Work Order ID 83088

Item Name: Crosstube Aft

DRAWING NO. D212-664-241	TITLE CROSSTUBE ASSY (205/212 HI AFT)	REV. D	DART AEROSPACE LTD ENGINEERING ORDER		D.E.O. NO. D212-664-241-D-1	SHEET NO. SHEET 1 OF 2	SCALE NTS
DRAWN	CHECKED	MFG. APPR.	APPROVED	DE APPR.			
DATE 11.04.07	DATE 11.04.11	DATE 11.04.12	DATE 11/04/12	DATE 11.04.12

ADD AN INSPECTION WINDOW TO UNDERSIDE OF CROSSTUBE.

D212-664-241/-241B
ASSEMBLY DETAIL

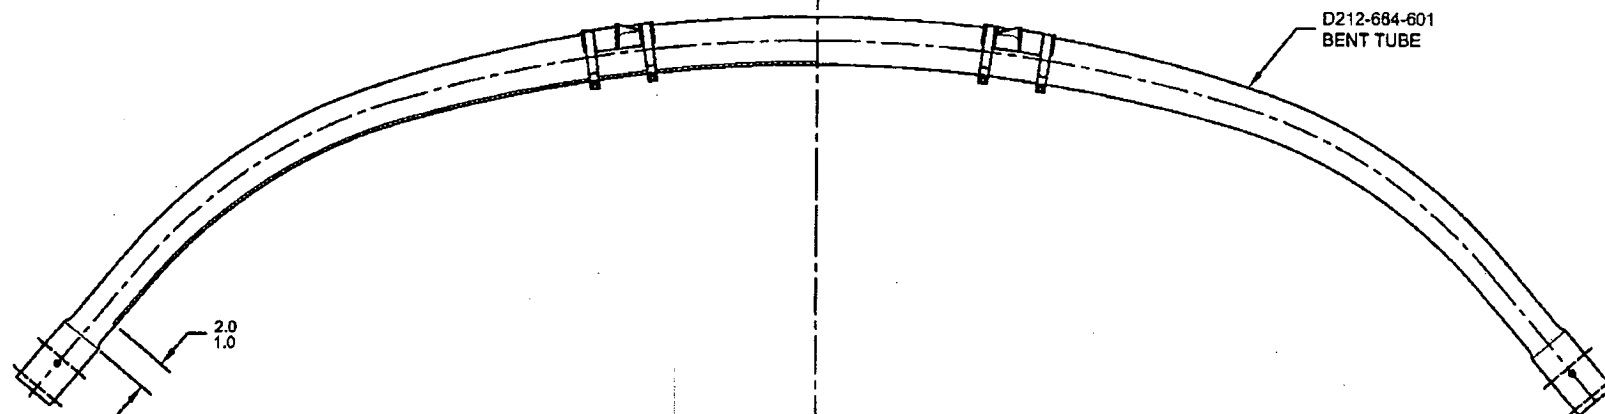
NOTES 2 OF SHEET 1 IS AMENDED AS FOLLOWS:

- 2) FINISH: CHEMICAL CONVERSION COAT PER DART QSI 005 4.1
PRIME INSIDE AND OUTSIDE PER DART QSI 005 4.2
MASK UNDERSIDE OF CROSSTUBE AS SHOWN (HATCHED AREA) AND
PAINT OUTSIDE PER DART QSI 005 4.2
REMOVE MASKING AND APPLY CLEAR COAT

- 2) FINISH: CHEMICAL CONVERSION COAT PER DART QSI 005 4.1
PRIME INSIDE AND OUTSIDE PER DART QSI 005 4.2
PAINT OUTSIDE PER DART QSI 005 4.2

MASK AREA PRIOR TO PAINTING,
REMOVE MASKING AFTER PAINT
AND APPLY CLEAR COAT

FIGURE 1: SUPPORT INSTALLATION

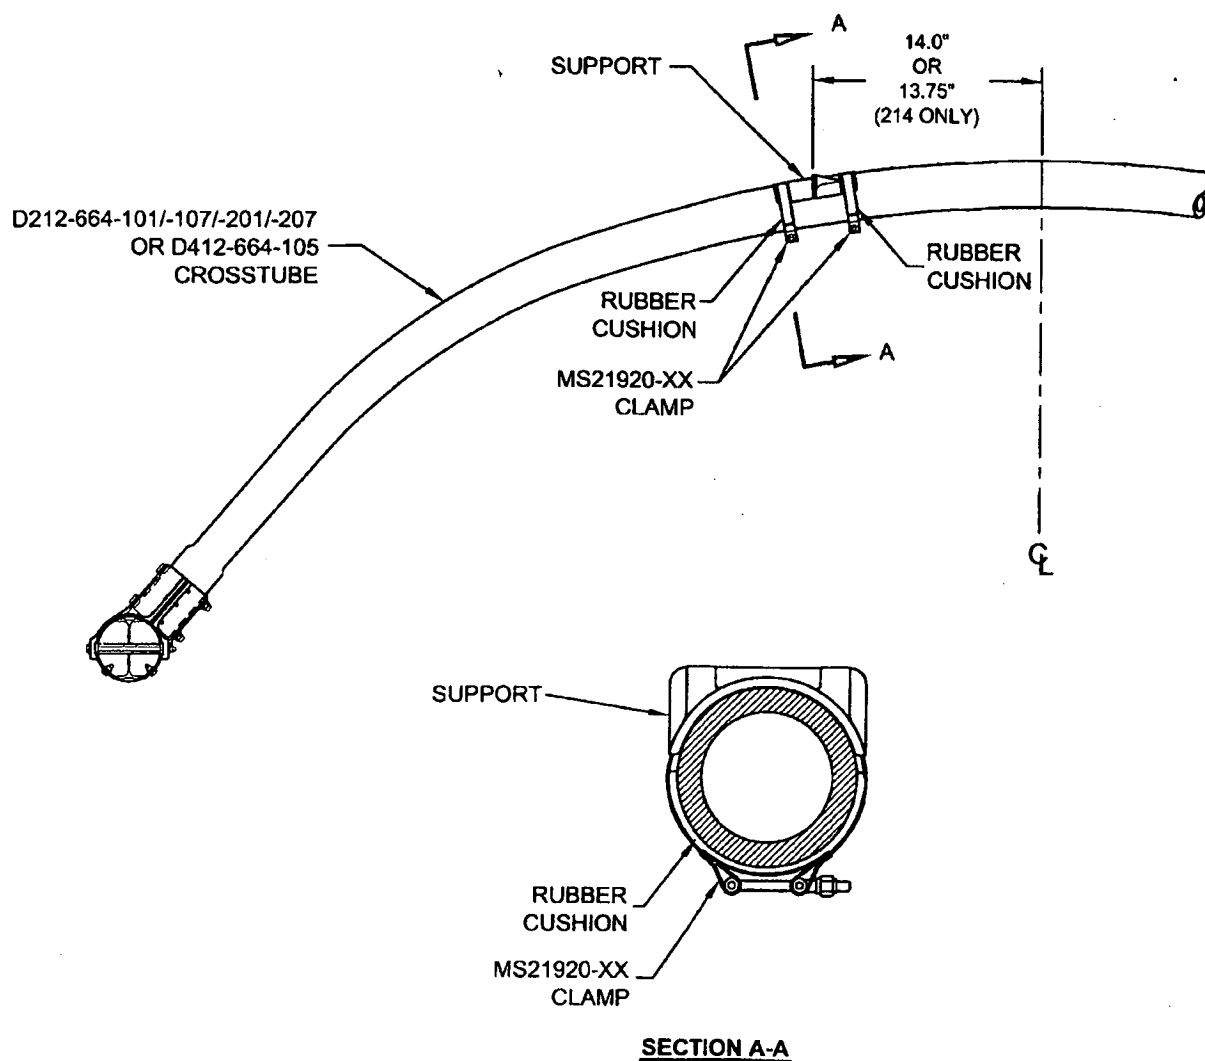
REPLACE MAGNOBOND WITH PROSEAL.

For the crosstubes listed above, section 32.4 of ICA-D212-664 is amended as follows. Use Figure 1 of this service instruction and Figures 32-2 to 32-9 of ICA-D212-664 for further reference. For crosstubes of an earlier change number, it is recommended that if the supports are removed, the supports should be reinstalled using the procedure listed below.

- 32.4.1 Locate the area on the crosstube for installation of support (see Figure 1 of this service instruction). For D212-664-101/-107/-201/-207 and D412-664-105 crosstubes, the outward face of the support tabs should be 14.0" (355mm) from the crosstube center for 204/205/210/412/UH-1 aircraft. For installation on 214B/B-1 aircraft, the outward face of the support tabs should be 13.75" (349mm). Ensure paint finish of crosstube is intact; touch up as required per Chapter 5 (5.3.9) of ICA-D212-664.

- 32.4.2 If present, remove any paint/primer on bottom of supports. Abrade mating surfaces of support and crosstube with 400-grit sandpaper. Saturate a clean cloth with MEK or 4105S Wash'n'Wipe Degreaser or equivalent and wipe until there is no residue.

- 32.4.5 Apply a 0.04" to 0.07" thick layer of Proseal 890 Class B or AMS-S-8802 Class B sealant underneath applicable support and install support as shown in Figure 1 of this service instruction.

- 32.4.6 Install the clamps opposite to crosstube support as shown in section A-A of Figure 1. Install rubber cushions underneath each clamp around the bottom circumference of the crosstube up to the crosstube centerline. Torque clamps 80-100 in-lb (9.0-11.3 Nm). It is acceptable to use smaller or larger sized MS21920-XX clamps than those listed in ICA-D212-664, ensure that after torquing the clamps per this instruction, the nuts are in safety but not bottomed out
